B2X Service Repair Information:	Swollen batteries on Nexus 6
Info ID:	SRI-EMEA-2015-03_Rev4
Countries:	EMEA
Carrier:	-
Repair Level:	L1 swollen battery Swap action - L2 Rework Action
Affected Models:	XT1100

This is an addendum for Motorola official Service Bulletin “UKRAEFSB2015-7Rev.2.1”. Please disregard previous versions.

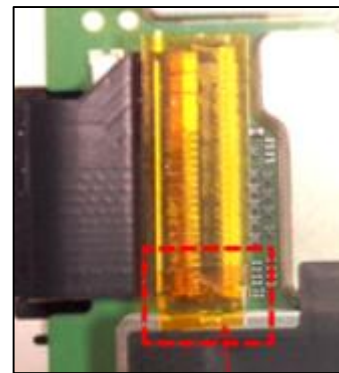
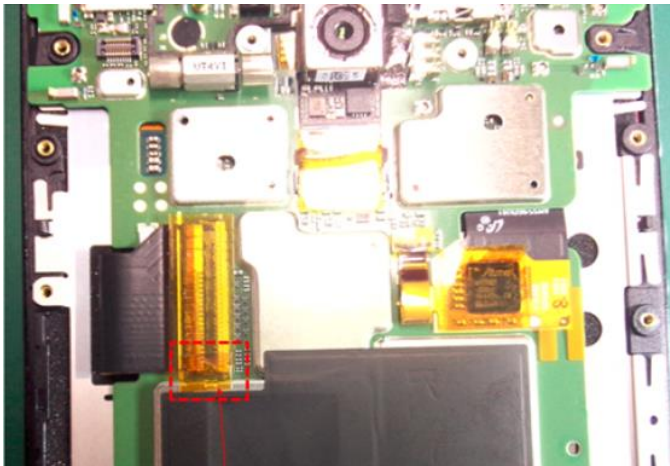
1. Following the Service Manual document, carefully disassemble the device.
2. After removing the Rear Cover Inlay (p/n: 0101805700x) inspect the device for Factory Rework Marking as shown below. If the device already has a factory marking, following steps do not apply.

If the device does not have a blue dot marking, continue the action as follows

3. Remove the existing EZ30 Battery Assembly (p/n: SNN5953A) and quarantine. Additional testing is required to determine if the removed batteries can be recovered and reused.

4. Place Kapton Tape (p/n: 11017572001) over the notch of APQ Shield (p/n: 26016344001) on PCBA.

5. Place a new EZ30 Battery Assembly (p/n: SNN5953A)
6. Mark reworked device, using a soft tipped Permanent Marker (do NOT use ball-point pen or other hard tipped marker). This is to identify if such devices come back through service channel again.

7. Following the Service Manual document, complete reassembly using new Rear Cover Inlay (p/n: 0101805700x) as this part cannot be reused.
8. Per normal service procedures, completely retest to ensure proper repair.
